## SVE BULLETIN

QVM Bulletin: Q-277

## Under Hood Electrical Equipment Mounting

**Models Affected:** 2017 and later Model Year Super Duty Pickups and Chassis Cabs

**Figure 1:** 2017 Super Duty Under Hood Plan View. Low clearance to underside of hood in areas highlighted in orange

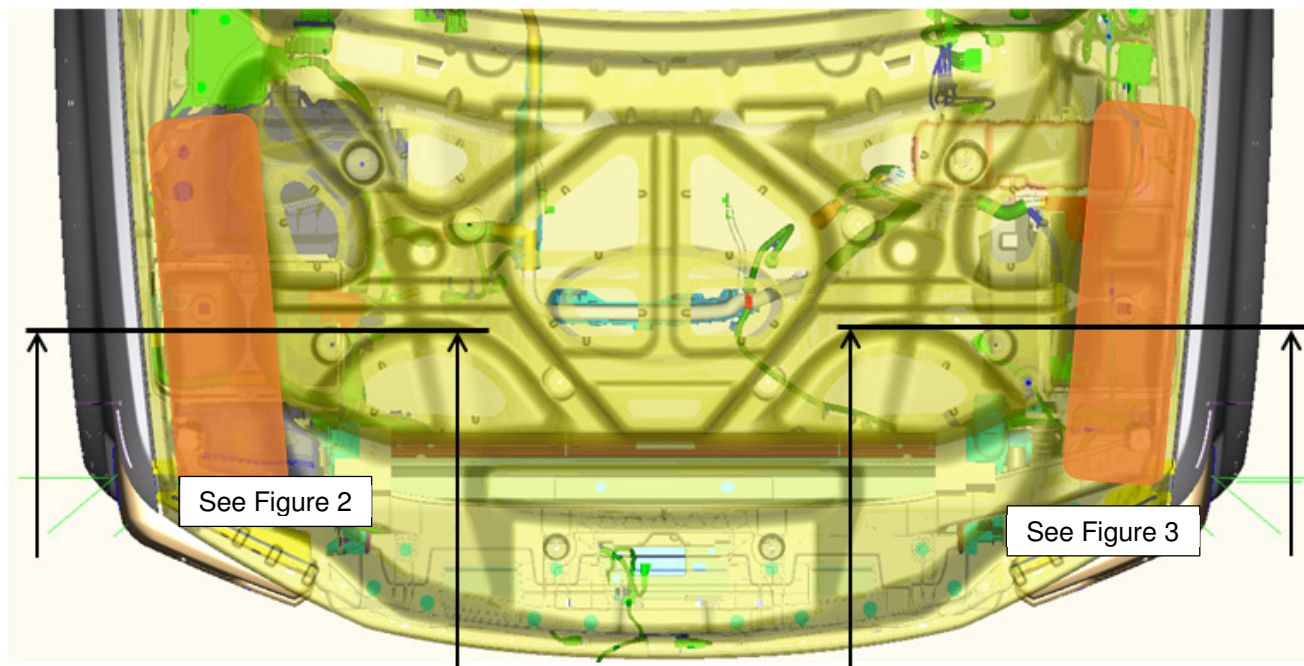
Do not mount or place electrical equipment, including but not limited to connection terminals, cables, relays, fuses, and fusible links on top of or near the primary or secondary battery in a location that has low clearance to the underside of the hood as indicated by orange rectangles in the figures that follow.

The reduced clearance to the underside of the hood for added electrical equipment on top of or near the primary or secondary battery may not be apparent when the hood is open. **If any B+ equipment is mounted in the low clearance zone as indicated by the diagram, a minimum of 15mm must be confirmed between bottom of hood and any equipment (including any B+ shielding and under hood insulation) mounted in the engine compartment when hood is fully closed.** Several methods exist to confirm equipment and shielding meets minimum clearance to bottom of hood (e.g. clay test, bore-scope).

**The upfitter must ensure that any electrical equipment or shielding mounted under hood does not come into contact with the hood or hood components.**

**Figures 2 & 3:** Vehicle X-Sections. low clearance areas (orange rectangles) for aftermarket equipment between battery & hood inner

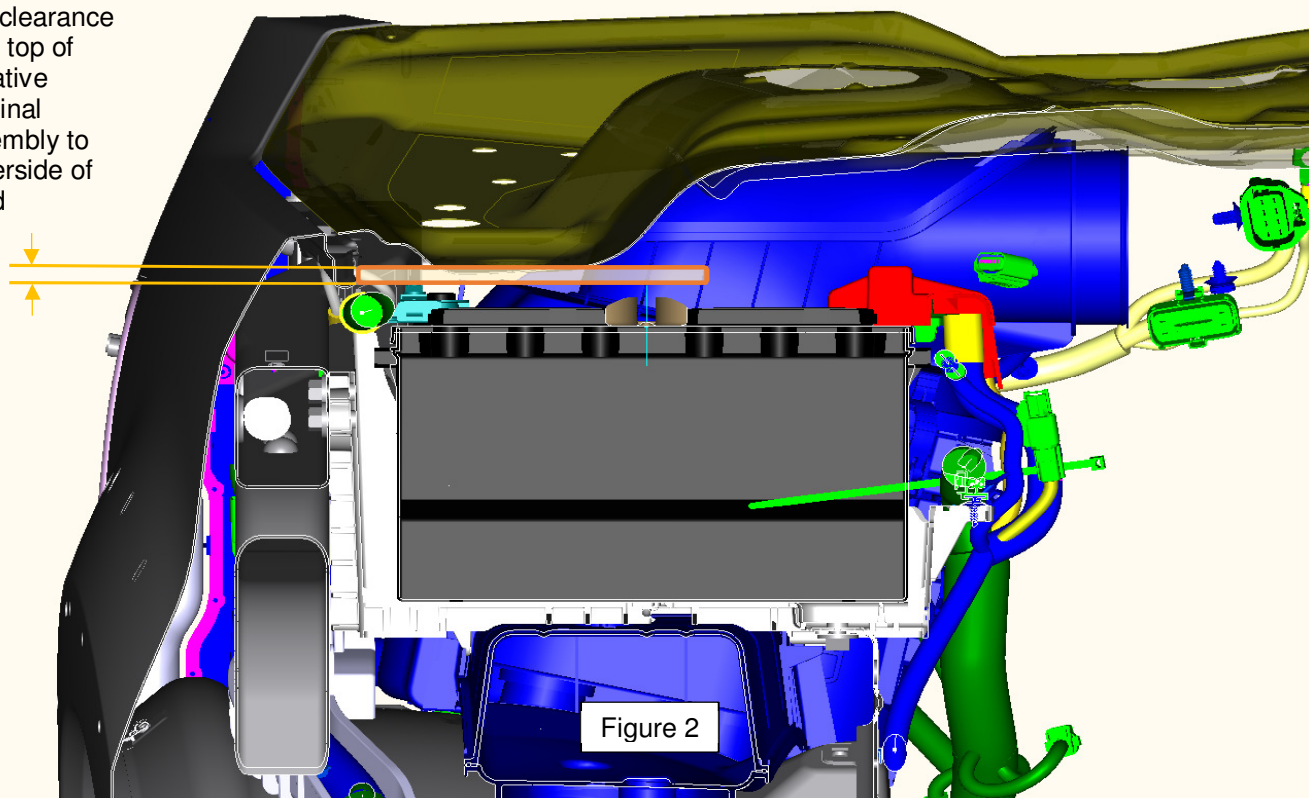
**Note:** only 16 mm clearance from top of negative terminal assembly to underside of hood

View- Front of vehicle left hand side
